INSPECTOR'S AS-BUILTS 1995
WWW ID# 8LDLWZ

**ROANOKE COUNTY
WATER TREATMENT
FACILITY**

ELECTRICAL DIAGRAM - TREATMENT
PROJECT ARCHITECT
R.L.J.
COMMISSION NUMBER
1913
TECHNICIAN
BAT
DATE
22 SEPT 1994

ELECTRICAL DIAGRAM - FIRST LEVEL - TREATMENT BUILDING
SCALE 1/8" = 1'-0"

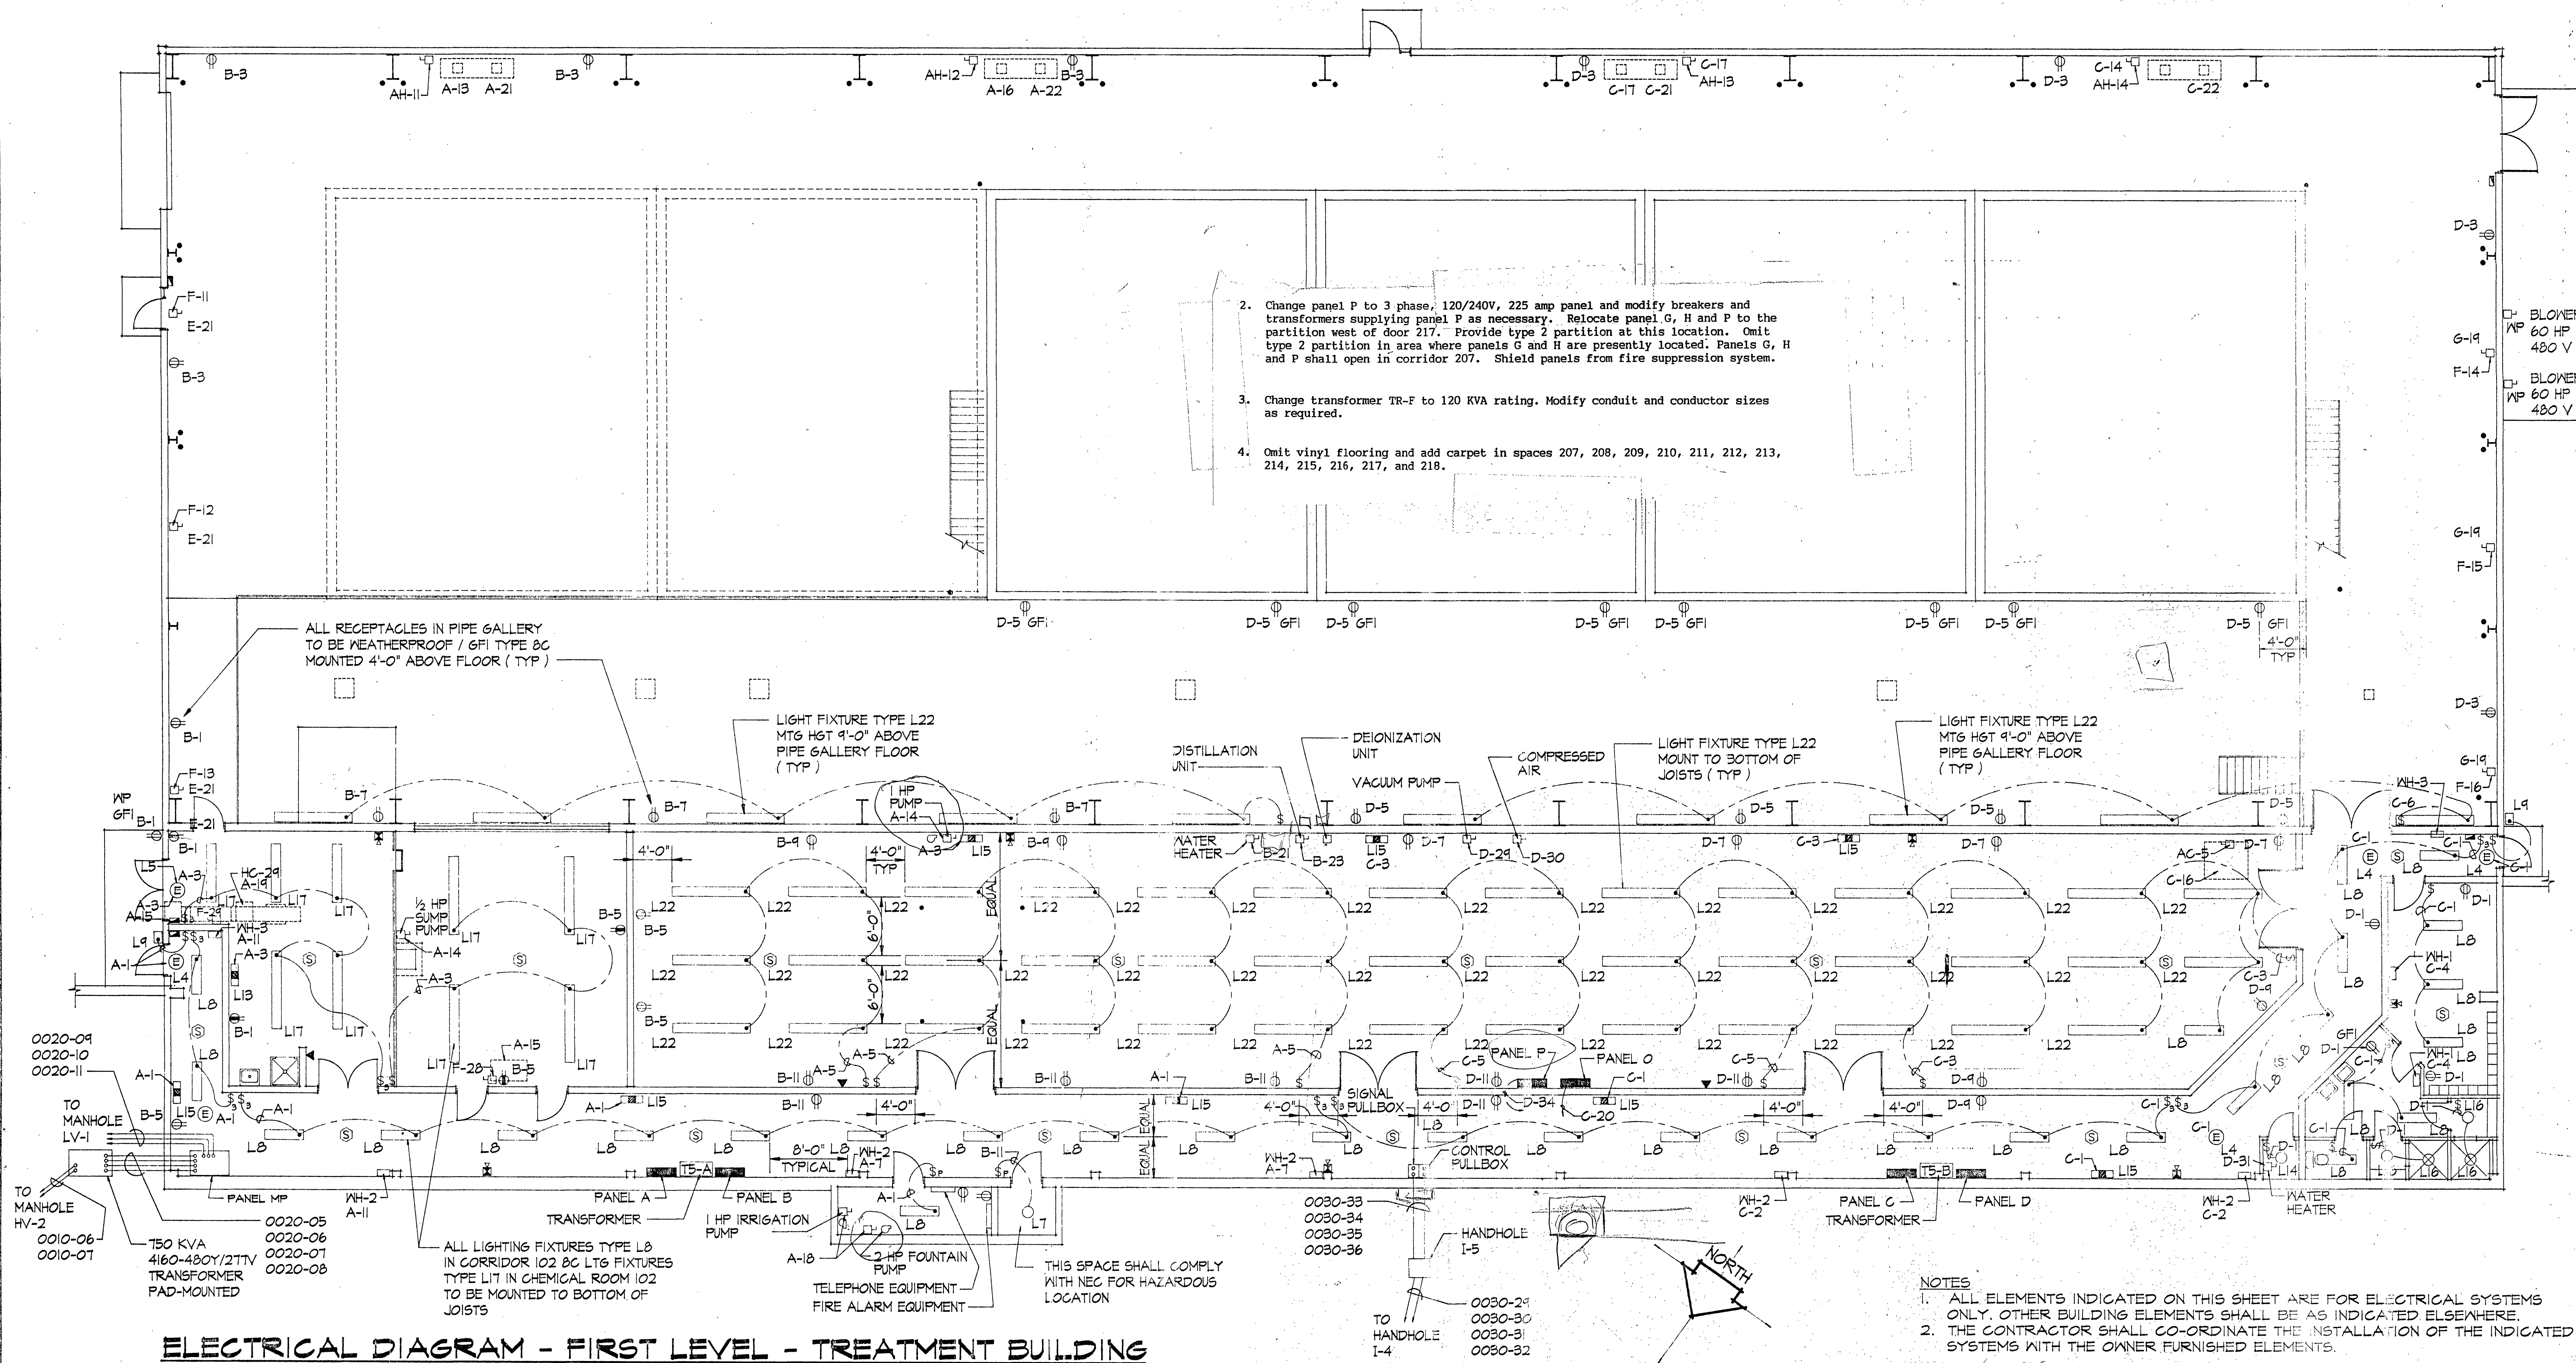
2. Change panel P to 3 phase, 120/240V, 225 amp panel and modify breakers and transformers supplying panel P as necessary. Relocate panel G, H and P to the partition west of door 217. Provide type 2 partition at this location. Omit type 2 partition in area where panels G and H are presently located. Panels G, H and P shall open in corridor 207. Shield panels from fire suppression system.
3. Change transformer TR-F to 120 KVA rating. Modify conduit and conductor sizes as required.
4. Omit vinyl flooring and add carpet in spaces 207, 208, 209, 210, 211, 212, 213, 214, 215, 216, 217, and 218.
